Hartland Township Planning Commission Meeting Agenda Memorandum

Submitted By: Troy Langer, Planning Director

Subject: Site Plan/PD Application #20-012 Newberry Place Planned Development – Preliminary Site Plan (Pattern Book submitted on April 15, 2021)

Date: June 3, 2021

Commercial District Lot Regulation

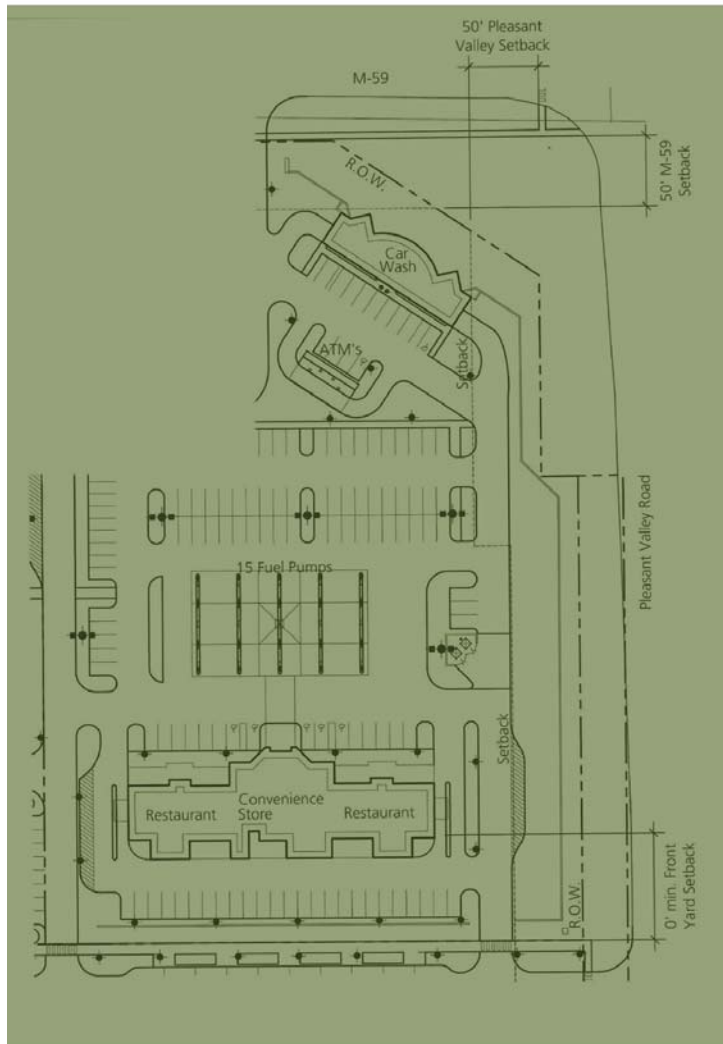
The Pattern Book does not include concept elevation drawings for an automotive fueling/gas station canopy. In the 2016 PD Plan submittal, the gas station canopy height was shown as 43 feet, as measured to the top of the architectural feature on the canopy.

100' Boulevard Landscape

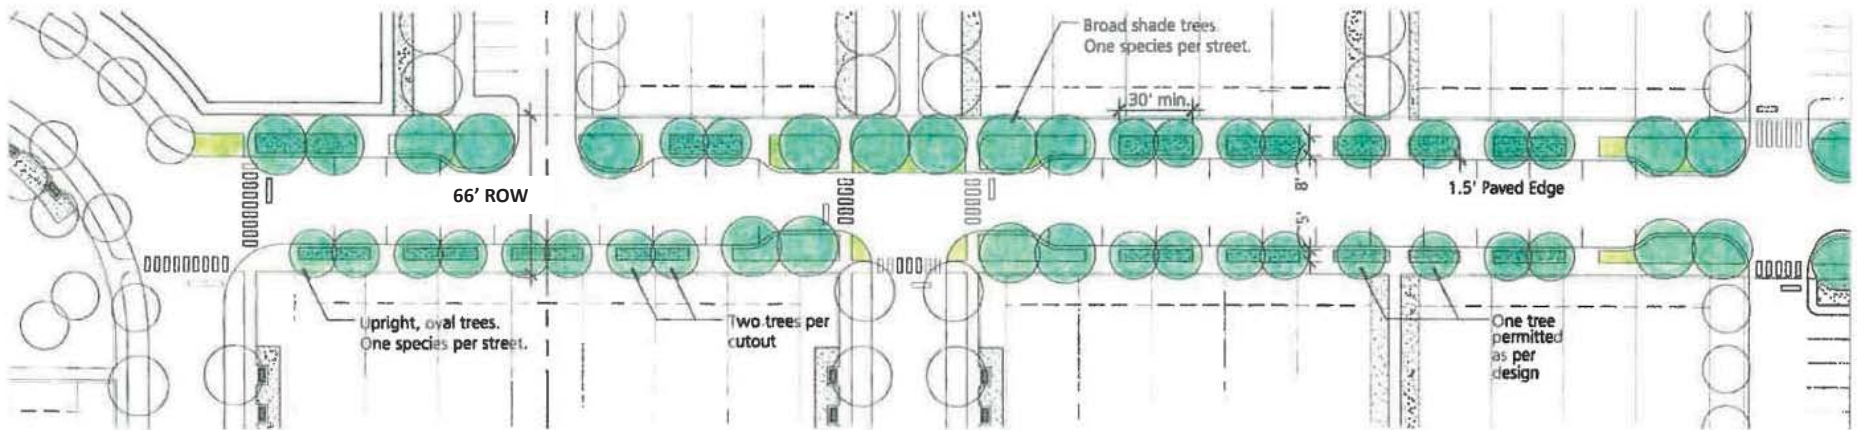
- 66' Entrance Street ROW is listed in the Legend but is not shown on the plan (olive green color)
- 110' Boulevard ROW should be added to the plan/legend with a specific color (located on south side of Highland Road)
- 100' Boulevard ROW should be added to the plan/legend with a specific color (located on north side of Highland Road)
- 5' Concrete Sidewalk should be shown on the south side of Highland Road, in place of the 8' Bituminous Bike/Safety Path, with a specific color on the plan/legend, to match that same color designation on Page 2 (Regulating Plan).
